Enclosure to 12/12/88 and mem  
to HSM from MKK

BWIP SITE TECHNICAL POSITION  
INTERPRETATION OF HYDROGEOLOGIC  
TEST IN DEEP BOREHOLES USING  
DATA OBTAINED BY UPHOLE MEASUREMENTS

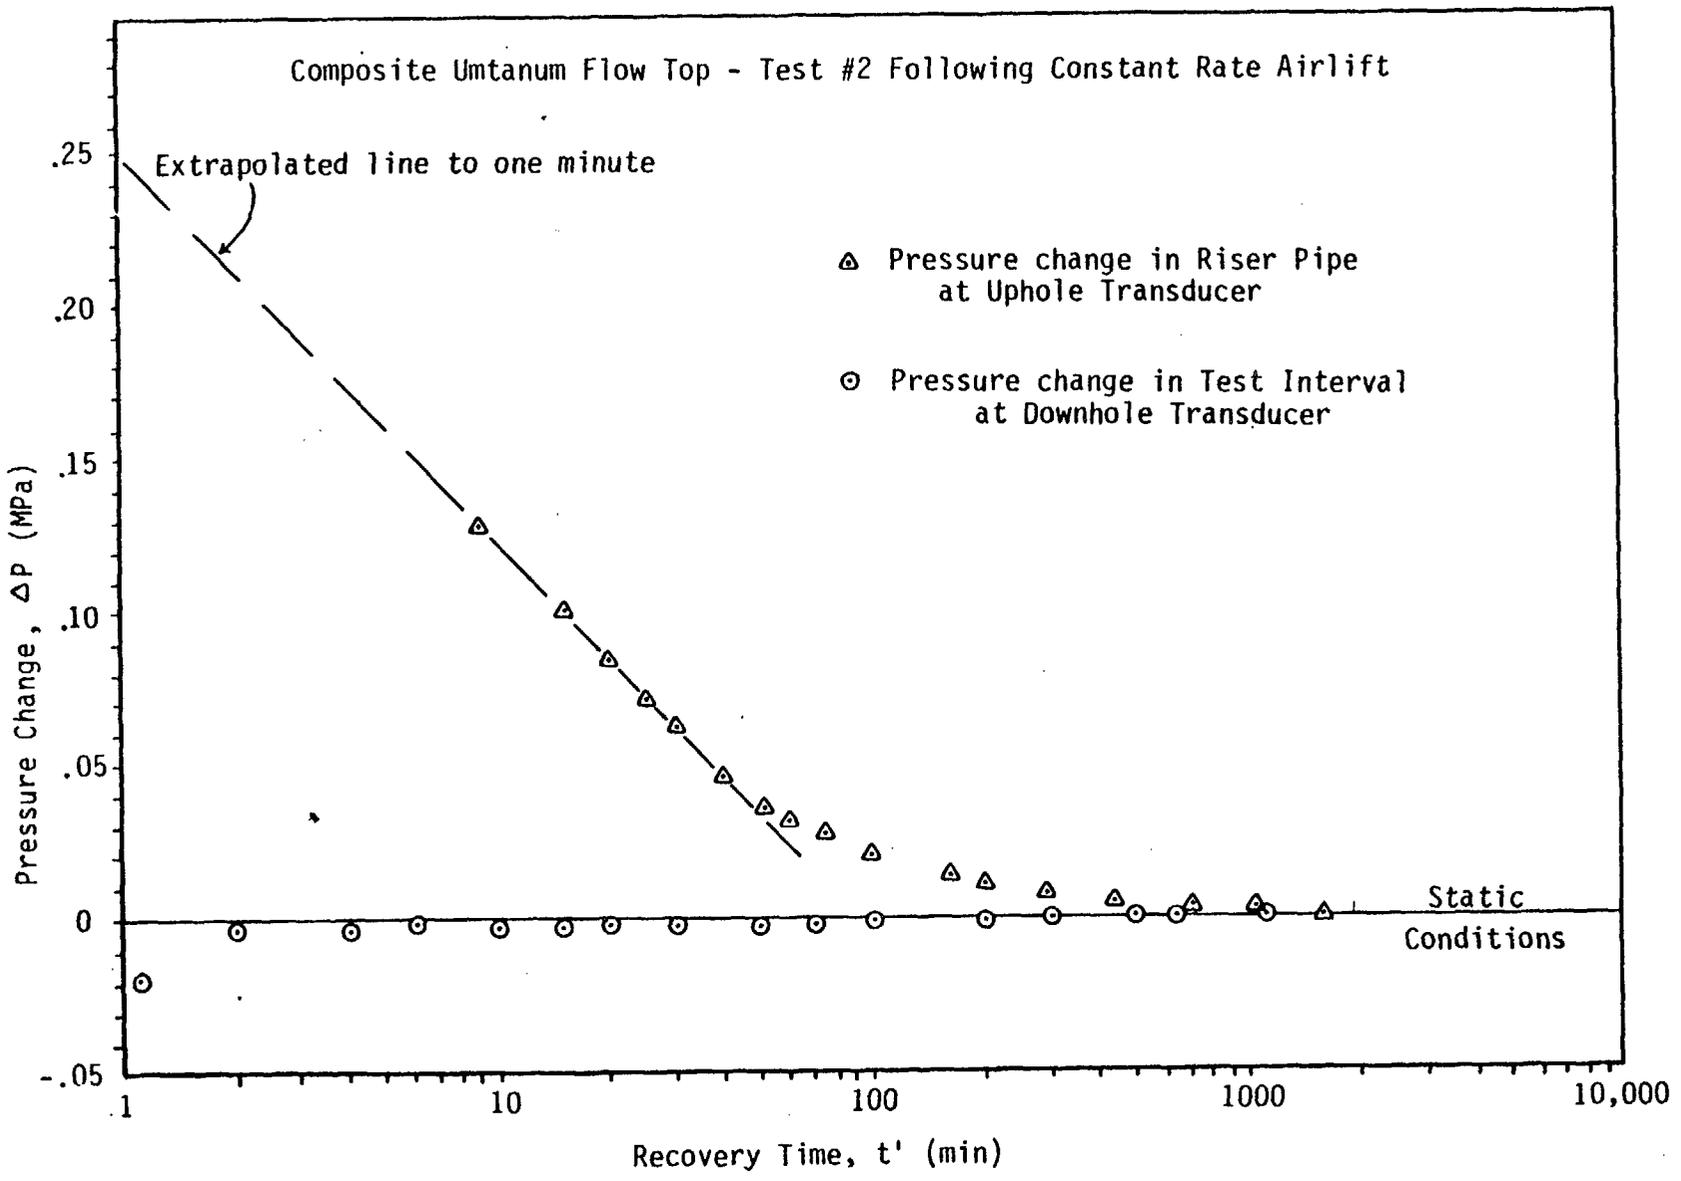
Figure 3-2 shows pressure changes that were measured with a shallow transducer during the recovery period of a constant discharge pump test conducted in the Composite Umtanum Flow Top in RRL-2 (Strait and Spane, 1982). Also shown are the pressure changes measured by a downhole transducer. At 9 minutes of recovery, downhole pressure had recovered to within  $3 \times 10^{-3}$  MPa below the static value. However, at the same time, pressure at the shallow transducer had overshoot pretest

conditions and was  $1.3 \times 10^{-1}$  MPa above static pressure. As recovery progressed, the pressure in the shallow transducer gradually fell to the static value.

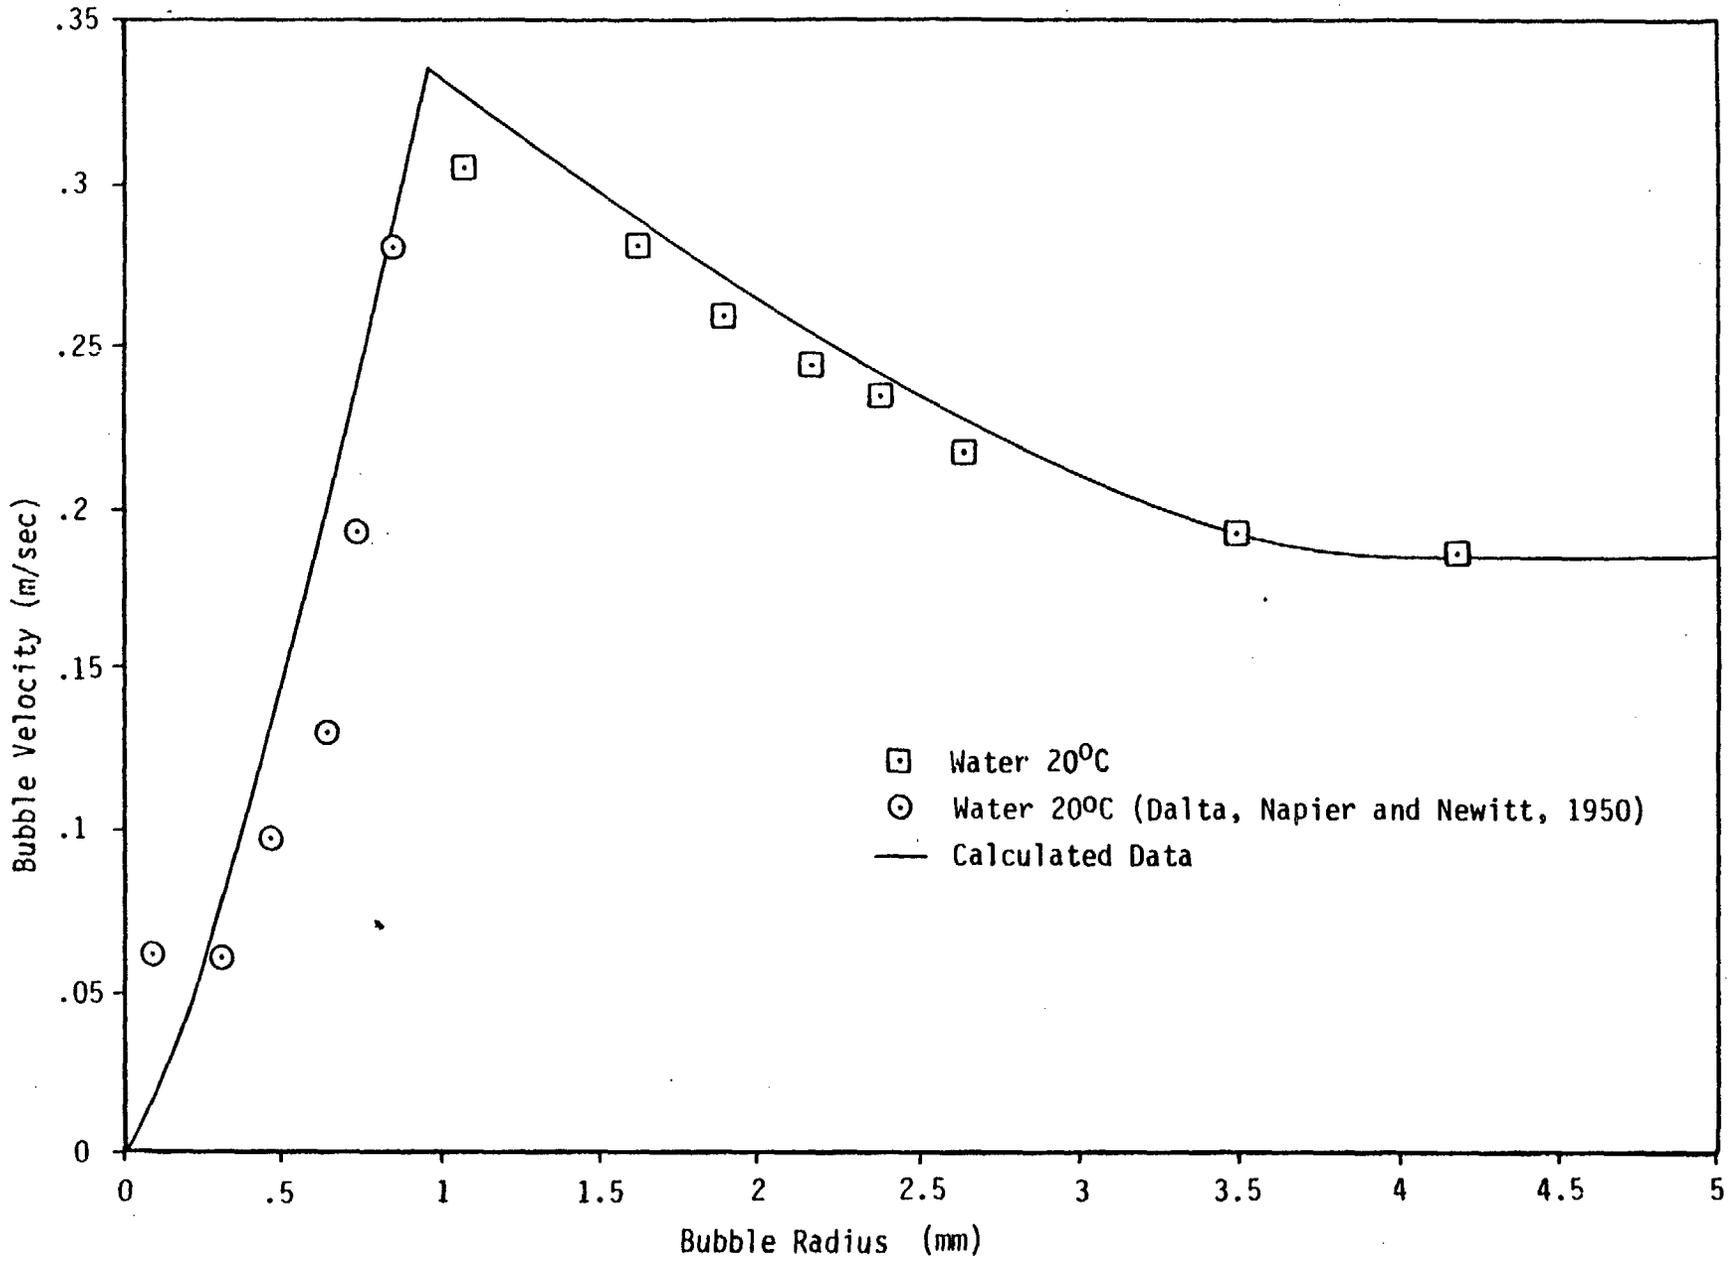
For an initial methane concentration of  $.702 \text{ kg m}^{-3}$ , the estimated maximum gas overshoot is 39 m above static water level. For an initial concentration of  $1.25 \text{ kg m}^{-3}$ , the estimated maximum gas overshoot is 83 m above static water level. These estimates of maximum gas overshoot indicate that dissolved gases coming out of solution may have a significant effect on observed overshoot.

Since a shallow pressure transducer (e.g., 20.7 m below static water level) was used to monitor the test response, the actual water level in the wellbore was not measured. Thus, the true density of the water/gas mixture above the shallow transducer cannot be determined. Assuming a fluid density of  $1000 \text{ kg m}^{-3}$  (i.e., no gas bubbles present) the observed pressure of  $13 \times 10^{-2} \text{ MPa}$  in the shallow transducer would correspond to an overshoot of 13 m at nine minutes after airlifting stopped. The extrapolated overshoot at one minute after airlifting stopped (see Figure 3-2) would be 26 m, again assuming no gas bubbles were present. Both values are less than the calculated overshoots.

However, if gas bubbles were present in the fluid above the shallow transducer, then the effective density of the fluid was less than  $1000 \text{ kg m}^{-3}$ . For an initial methane concentration of  $.702 \text{ kg m}^{-3}$ , the fluid density near the shallow transducer would be approximately  $680 \text{ kg m}^{-3}$  (calculated by the model in Section 3.3.1) which would correspond to an overshoot of 19 m at nine minutes. For an initial methane concentration of  $1.25 \text{ kg m}^{-3}$  the fluid density would be  $540 \text{ kg m}^{-3}$  and the overshoot would be 25 m according to the model.

This suggests that gas may not be released instantaneously and/or that a significant volume of degassed methane may have escaped into the atmosphere at early times in the water-level recovery. In the next section, overshoot decay due to gas bubbles escaping will be estimated.

Figure 3-10

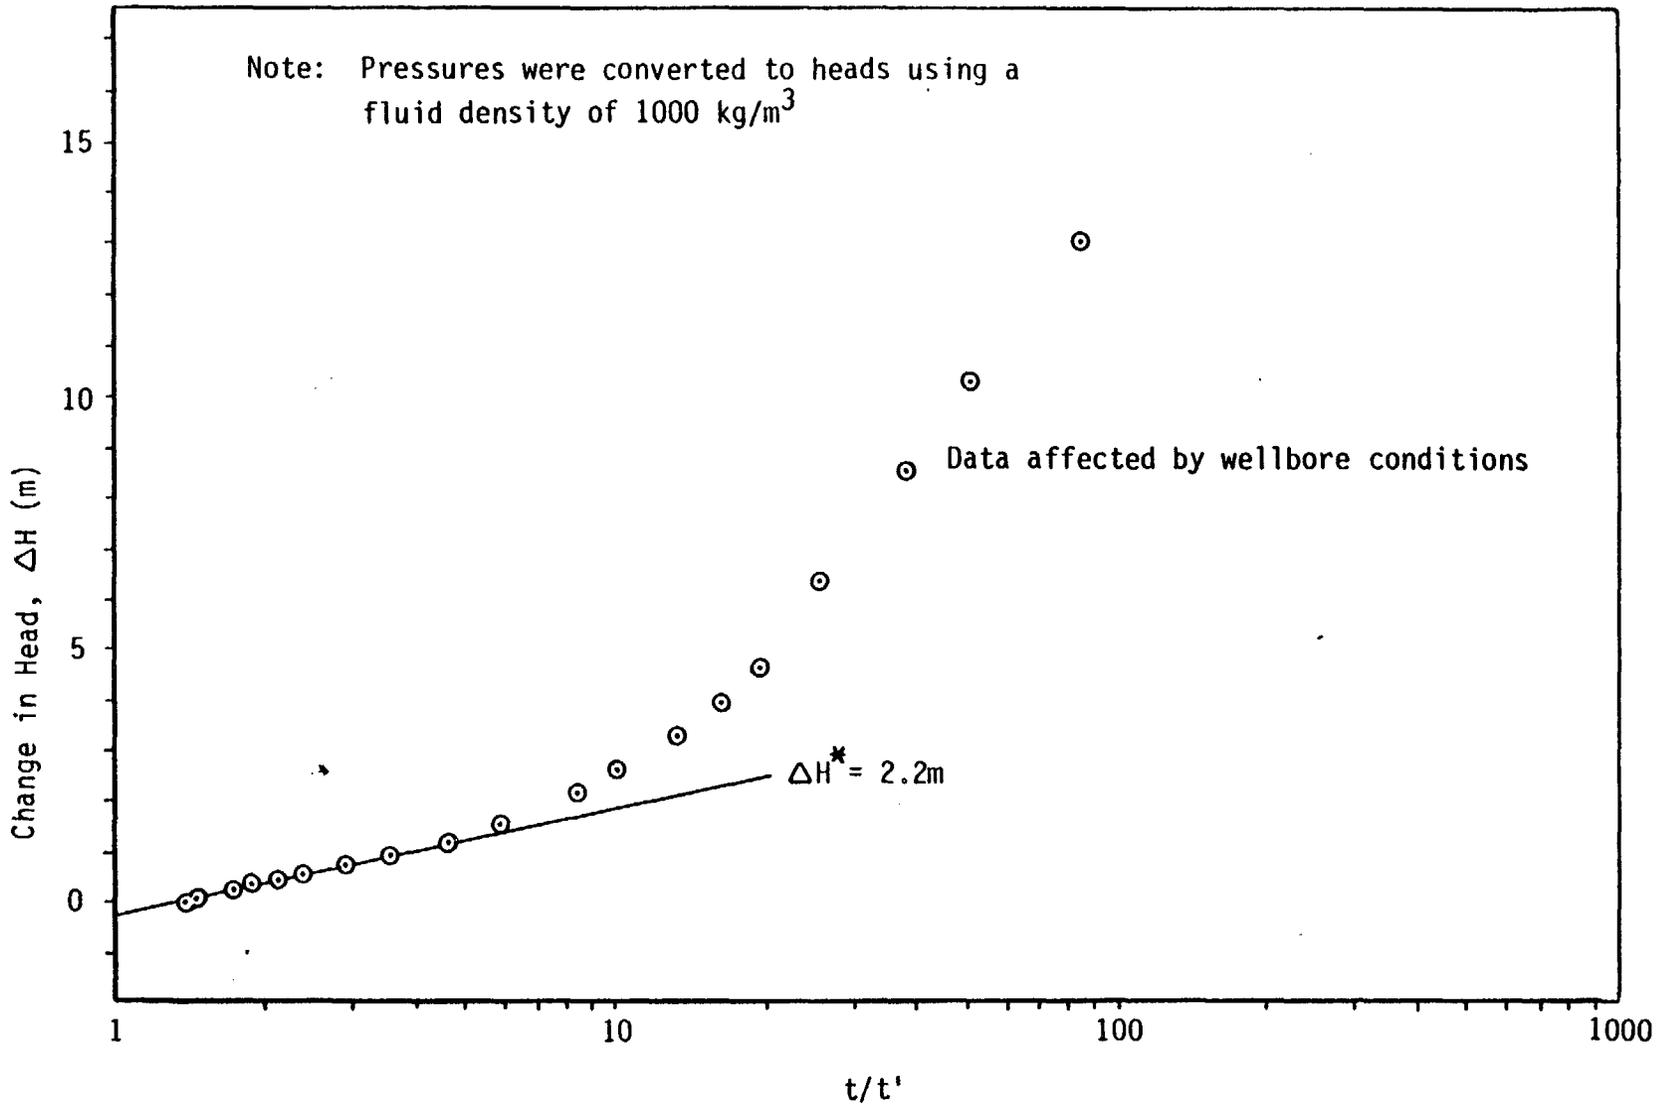
As an example equation (3-21) has been applied to conditions encountered in the Composite Umtanum Flow Top in RRL-2. Substitution of  $\Delta H_{\max} = 7.2$  meters and  $C = 3.9$  into equation (3-22) gives a predicted  $\Delta H^*$  value of 1.6 meters.

In Figure 3-10, water-level overshoot data for the Composite Umtanum Flow Top are plotted on the semilog format. Uphole transducer pressures have been converted to heads using an assumed constant density of  $1000 \text{ kg m}^{-3}$  to permit comparison with the calculated values. Since early recovery data were probably affected by wellbore conditions, the semilog straight line was fit to later time data (e.g., small  $t/t'$  values). Use of this procedure gives a  $\Delta H^*$  value of 2.2 meters which is close to the value predicted by the thermal model (1.6 meters).

In this example, the observed overshoot recovery response was similar to the predicted response based on a physical model of thermal conditions in the borehole. The results suggest that thermal expansion of water in the riser pipe may be a significant factor in controlling overshoot decay. The effects of degassing and thermal decay may be occurring at the same time in recovery tests.

Figure 3-11

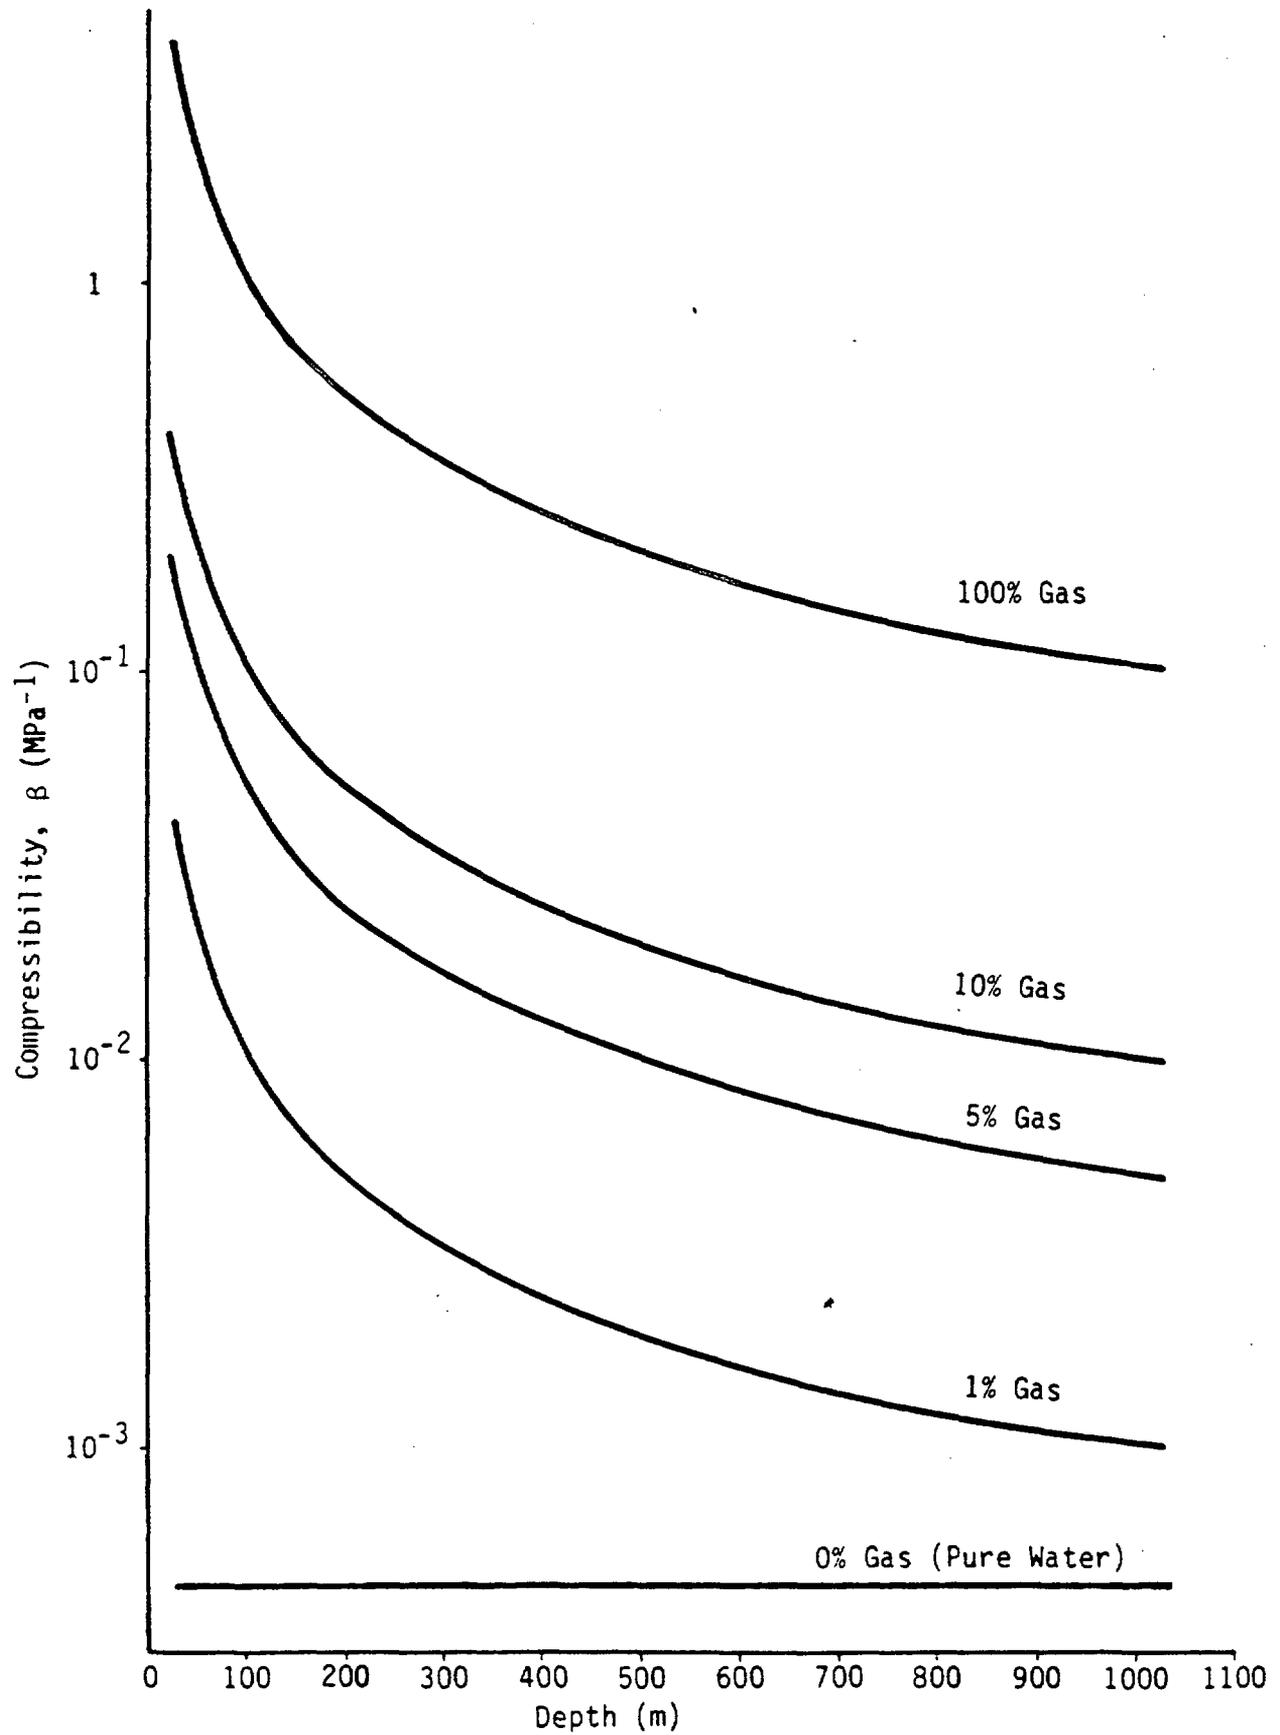
Where  $P$  is measure in Pa. The coefficient of compressibility for methane and for methane/water mixtures was estimated for each interval in the riser pipe. These results are shown on Figure 3-11. The compressibility of pure water is also shown for comparison.

Note that the compressibility of a methane/water mixture with even one percent methane bubbles shows a marked increase in compressibility over pure water alone. Thus, analytical solutions for slug test response which ignore wellbore compressibility could be significantly in error. The compressibility of packers and the riser pipe will contribute to this error.
